Access Compliance Report

Public Rights-of-Way

(Curb Ramps)

Intersection ID: 25067	Main Street: CARRIAGE_LAKE_DR	Cross Street: SMITH_RD	Location: SE
ADA ID: F17BC4FB104D	Ramp Type: BlendTrans2	Initial Pass/Fail: Pass	Overall Compliance: No
		Severity Score: 2.5

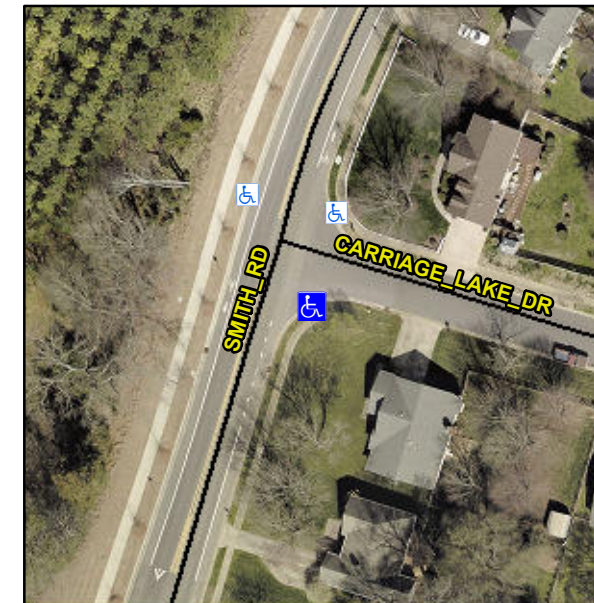
Not Found, R305.1.4, R305.2, R304.5.3

N/A	Ramp inside XWalk1?	N/A	N/A	Ramp inside XWalk2?	N/A
	Road Slope (%)	1.5		Clear Space?	Yes
	Road X Slope (%)	1.2	N/A	Clear Space to XWalk (in)	N/A
Yes	Any Obstructions?	No	Yes	Storm Grate/Utility Hazard?	No
	Obstruction Type			Storm Grate/Utility Type	
		N/A			N/A
			Yes	Surface Condition? (G/P)	Good
			No	Curb Slope (%)	33.6

Remove & Replace Curb Ramp With Two New Directional Ramps or Equivalent. Remove & Replace Gutter.
